**09. Letter from Aruna Prabhala, Kevin Bundy, Ileene Anderson, Center for Biological Diversity, dated February 13, 2017**

**Figure 1. Seasonal Flow Conditions and Timing of Construction Activities**

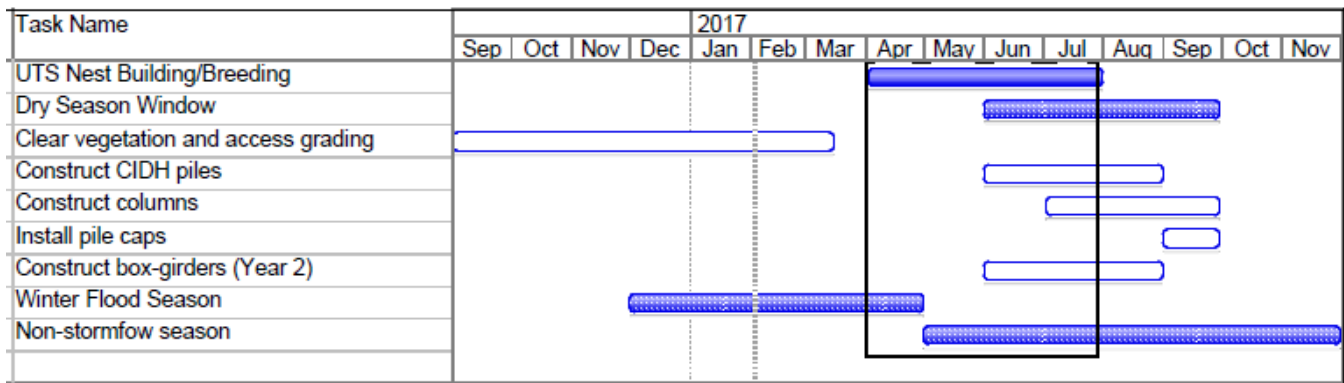
breeding season (Figure 1) via construction intrusions into the hyporheic zone, below the water table, where UTS may inhabit wetted interstitial spaces between riverbed sediments.

**Figure 2. Santa Clara River Streamflow Duration Hydrograph**

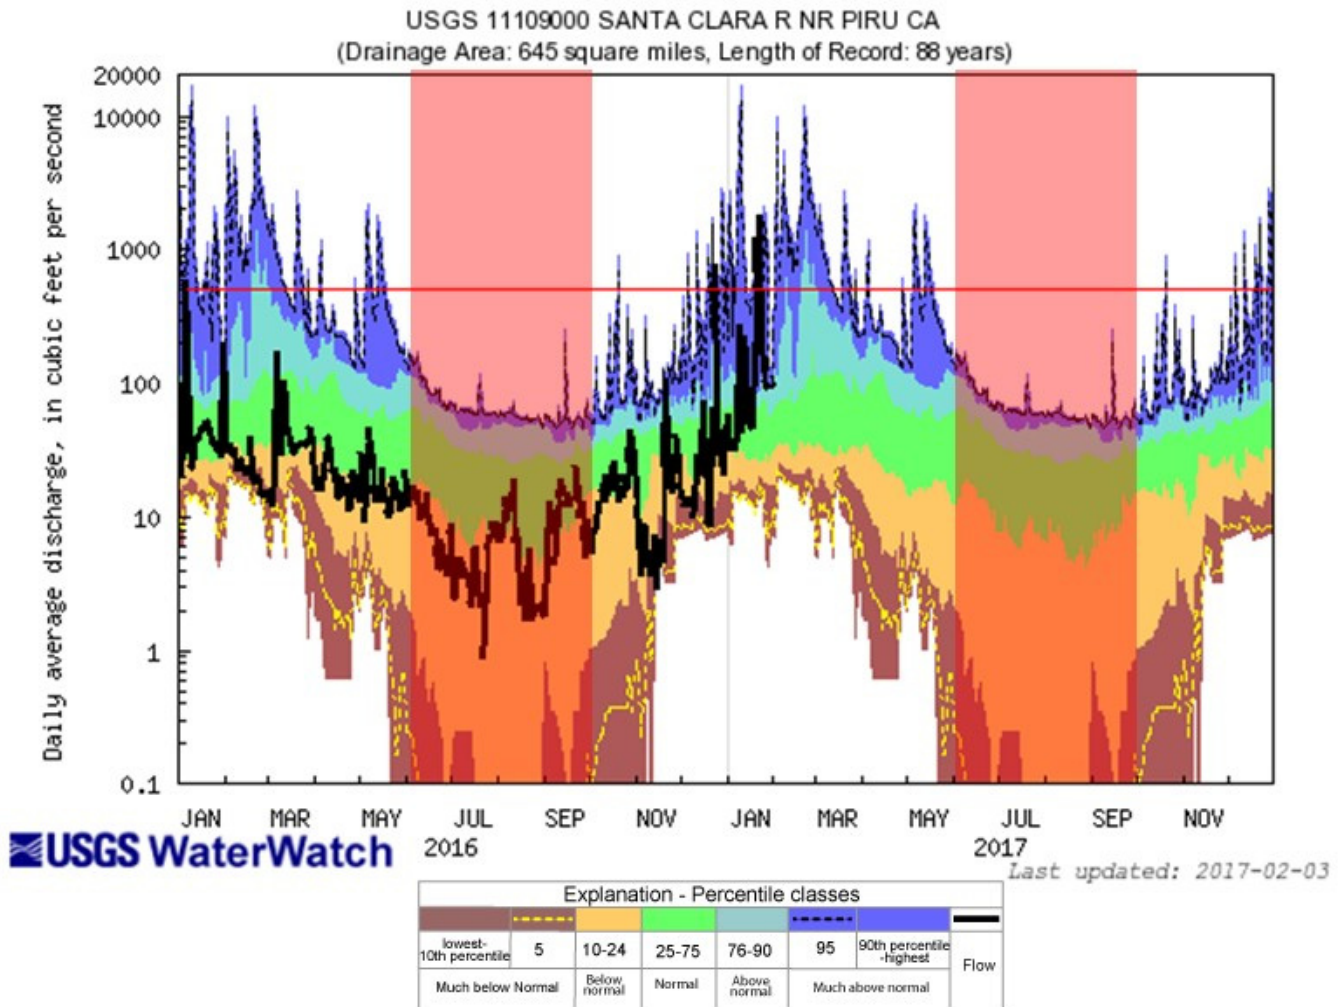
Figure 2 shows the last 2 years of recorded flow data (black line) for USGS gage 11109000, the June through September dry season construction windows (pink boxes), and the 500 cfs value (red line). The colored areas show long-term statistics of streamflow for each day of the year at that station and the top of

The comment describes Figure 2 from the Geosyntec 2016b memorandum, but does not raise any issue as to the adequacy of the Draft AEA. Therefore, no further response is required.
